April 7, 1997

Re: Technical Specification Change
Notification of Change in University Management as Required by the Breazeale
Nuclear Reactor Technical Specifications
License No. R-2, Docket No. 50-5

ORGANIZATION CHART

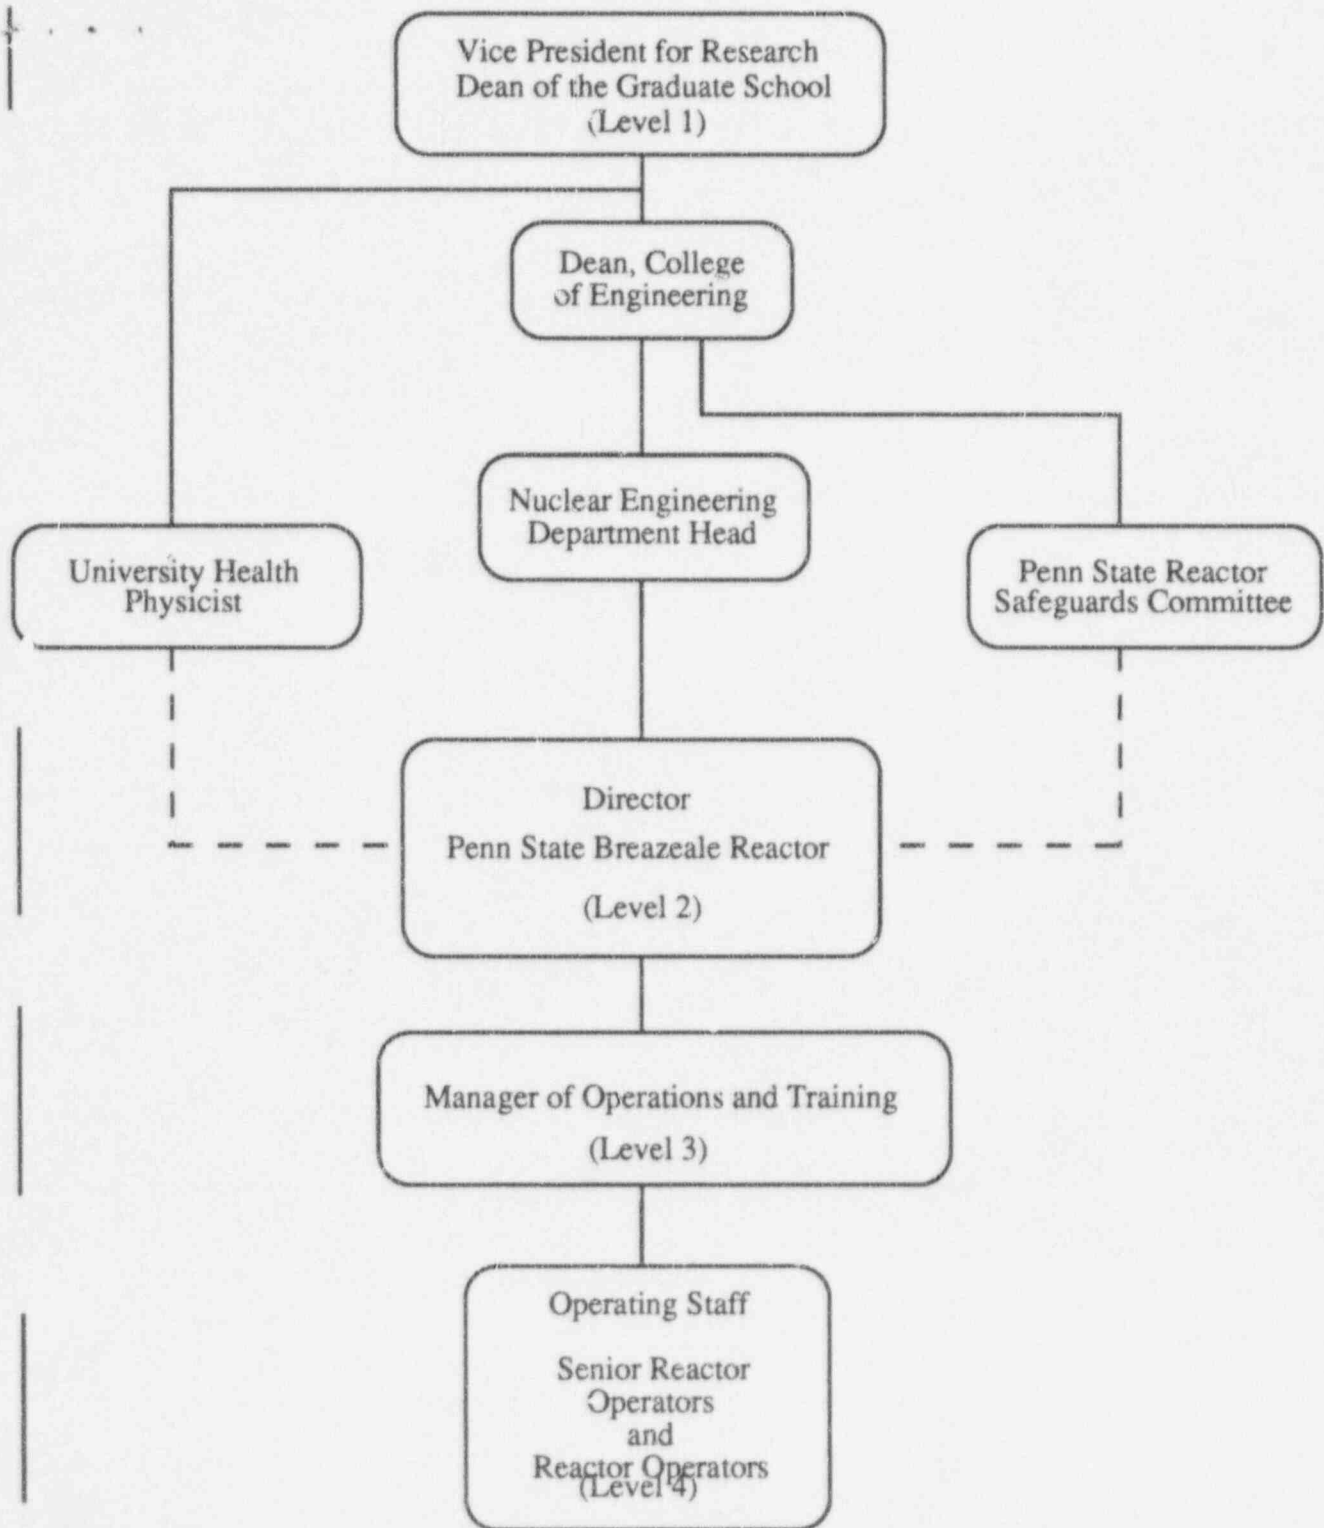
A copy of the proposed Technical Specification change to reflect Dr. Erickson's title is enclosed. This organization chart incorporates other changes that were submitted as pending Amendment No. 32 on February 6, 1997.
